UNITED STATES  
NUCLEAR REGULATORY COMMISSION  
WASHINGTON, D. C. 20555

Docket No. 50-213  
LS05-80-11-044

CONTROL NO. (PRE-NUMBER)	B-265
PDCR NO.	387

TITLE	Spent Resin Storage Facility	PA 79-259
-------	------------------------------	-----------

CONN YANKEE ATOMIC POWER COMPANY	
SPENT RESIN STORAGE CELLS	
	FIG. 2

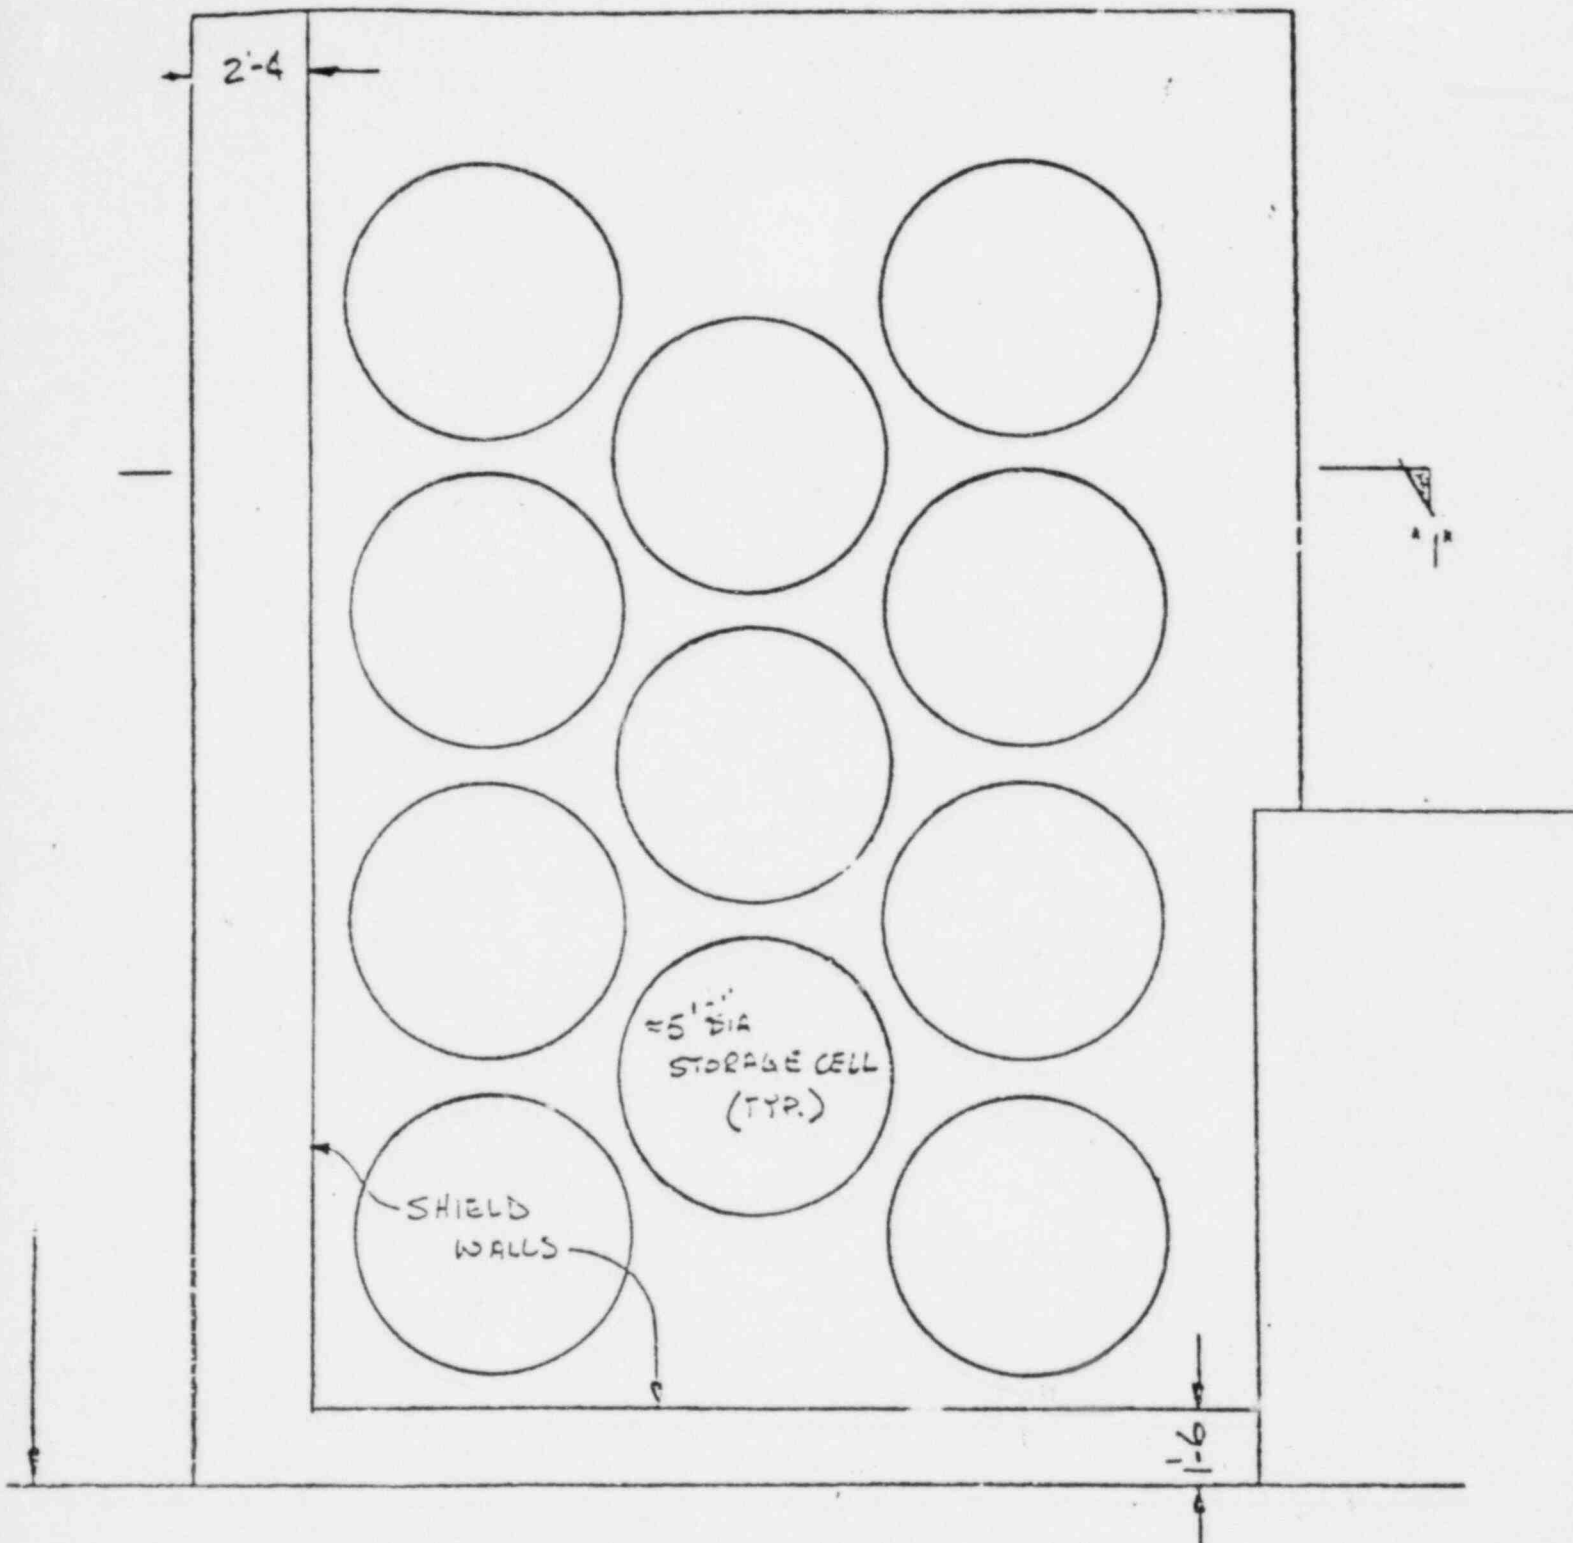
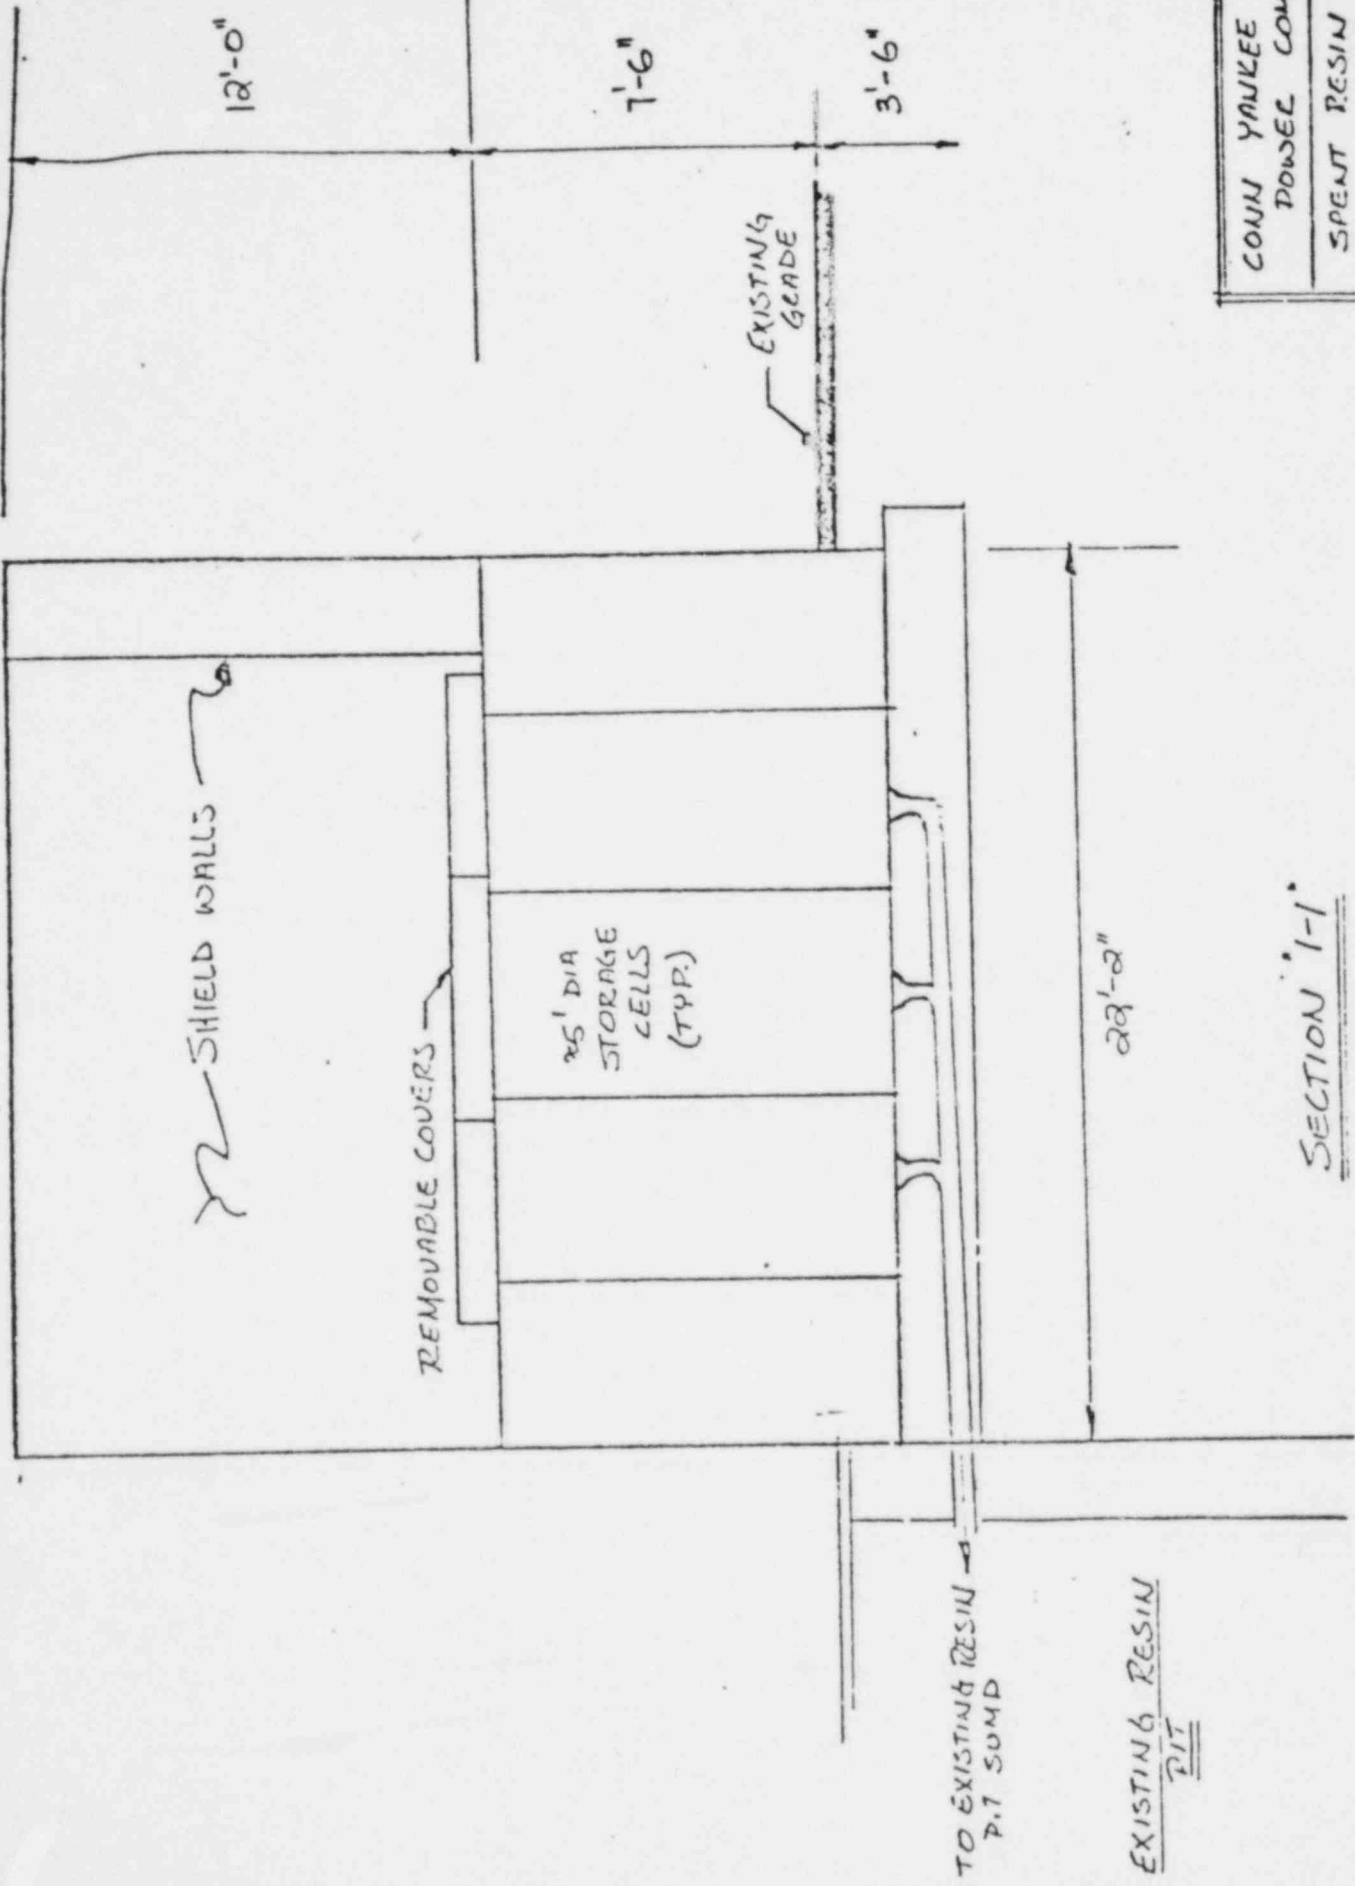
In order to facilitate the transferring job, a bevel should be built on top of each cylindrical cell.

The sketched drawings show the ID of the cylindrical cells as 5'. Since Chem. Nuclear resin liners are 5'1" diameter (OD), the cells ID should be changed to 5'2".
